## HISTORIC AND DESIGN REVIEW COMMISSION

December 2, 2020

**HDRC CASE NO:** 2020-417  
**ADDRESS:** 253 LOTUS ST  
**LEGAL DESCRIPTION:** NCB 2956 LOT S 68 FT OF E NCB 3036 LOT E TRI 46 FT OF 24  
**ZONING:** R-6, H  
**CITY COUNCIL DIST.:** 1  
**DISTRICT:** Lavaca Historic District  
**APPLICANT:** Adams Joseph/MATHEW ANGELINE & ADAMS J JOSEPH  
**OWNER:** Adams Joseph/MATHEW ANGELINE & ADAMS J JOSEPH  
**TYPE OF WORK:** Stucco over wood siding, window replacement  
**APPLICATION RECEIVED:** September 21, 2020  
**60-DAY REVIEW:** Not applicable due to City Council Emergency Orders  
**CASE MANAGER:** Huy Pham  
**REQUEST:**

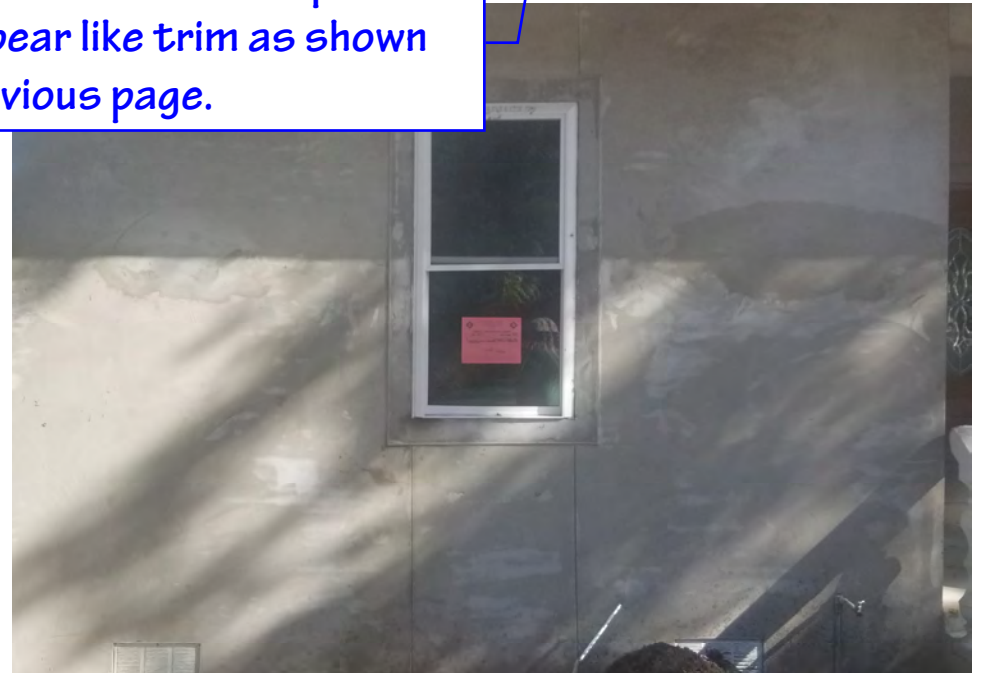
Grey would be  
color matched

Aside from the screens  
the windows look the same  
from the street.

Area inside of red box has been  
digitally colored

As home looks today.

Raised stucco around doors and windows would be painted to appear like trim as shown on previous page.
